Proposed Revisions to a Standard Plans Index

Index Number: 455-118

Index Title: 18" CFRP & SS Prestressed Concrete Piles

Sheet Number (s): 1

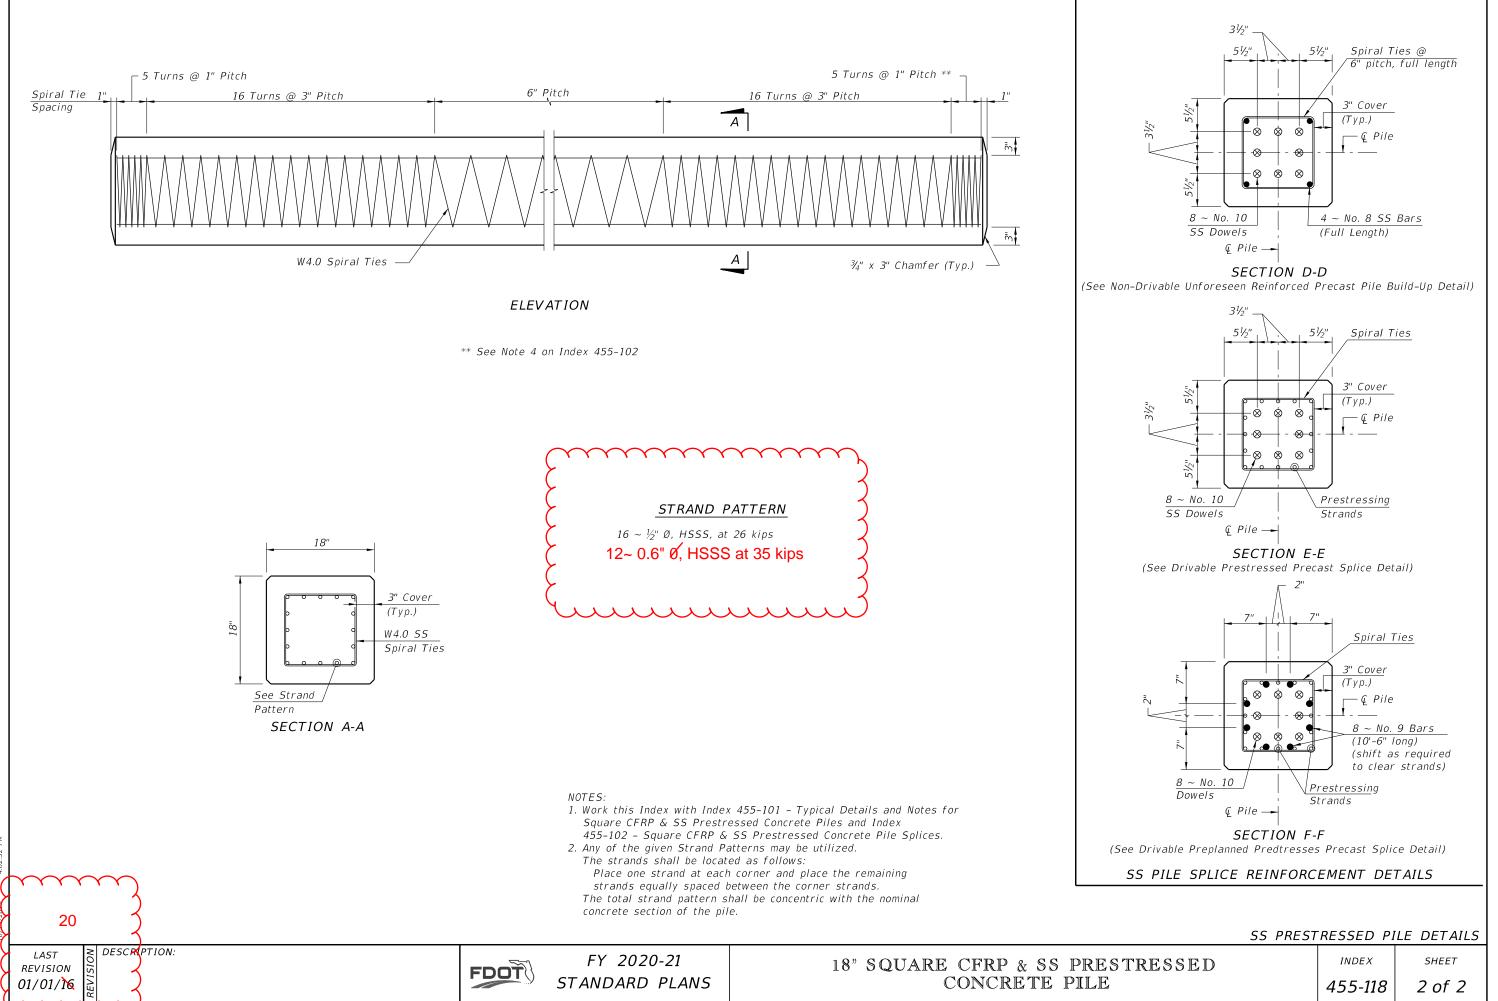
Added 0.6" HSSS strand
